MILITARY SPECIFICATION

CONNECTORS, MINIATURE AUDIO, FIVE PIN AND SIX PIN

GENERAL SPECIFICATION FOR

This amendment forms a part of MIL-C-55116B, dated 31 July 87, and is approved for use by the Department of the Army and is available for use by all Departments and Agencies of the Department of Defense

FIGURE 3: ADD SIDE VIEW TO PICTORIAL VIEW

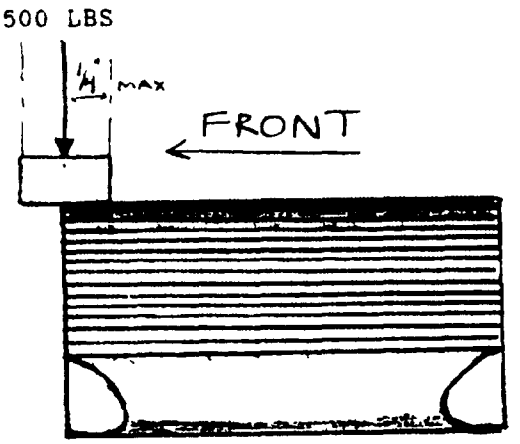
PAGE 29
